Access Compliance Report

Public Rights-of-Way

Intersection ID: 2913	Main Street: CREEK_BREEZE_RD	Cross Street: MEADOWVIEW_HILLS_DR	Location: SW
ADA ID: 9A9BFF5AE0DF	Ramp Type: PerpDiag	Initial Pass/Fail: Fail	Overall Compliance: No
Severity Score: 13.75			
Codes/Mitigation Info/Possible Solution		Field Measurements/Component Compliance

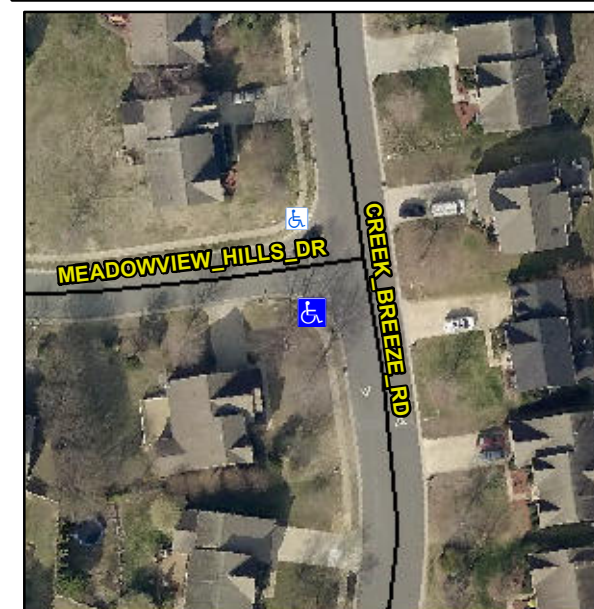
R304.2.2, R304.5.3

Compliance	Description	Data	Compliance	Description	Data
N/A	Ramp Length (in)	43.0	No	Ramp Slope (%)	11.2
Yes	Ramp Width (in)	56.0	No	Ramp XSlope (%)	4.1
N/A	Flare Type LT	N/A	N/A	Flare Type RT	N/A
N/A	Flare Slope LT (%)	N/A	N/A	Flare Slope RT (%)	N/A
N/A	Flare Traversable LT?	N/A	N/A	Flare Traversable RT?	N/A
N/A	Landing Length (in)	N/A	N/A	DWS Provided?	N/A
N/A	Landing Width (in)	N/A	N/A	DWS Contrast?	N/A
N/A	Landing Slope (%)	N/A	N/A	DWS Length (in)	N/A
N/A	Landing X Slope (%)	N/A	N/A	DWS Full Width?	N/A
N/A	Landing Curb? (Y/N)	N/A	N/A	DWS Offset (in)	N/A
N/A	Shared Landing?	N/A			
N/A	Gutter Ponding?	N/A	N/A	Gutter Slope (%)	N/A
N/A	Gutter Lip Ht (in)	N/A	N/A	Gutter X Slope (%)	N/A
N/A	Painted X Walk1?	No	N/A	Painted X Walk2?	No
	X Walk 1 Direction	To E		X Walk 2 Direction	To N
N/A	X Walk 1 Width (in)	N/A	N/A	X Walk 2 Width (in)	N/A
	X Walk 1 Slope (%)	6.6		X Walk 2 Slope (%)	5.9
	X Walk 1 X Slope (%)	3.2		X Walk 2 X Slope (%)	2.5

Remove & Replace Curb Ramp With Two New Directional Ramps or Equivalent.
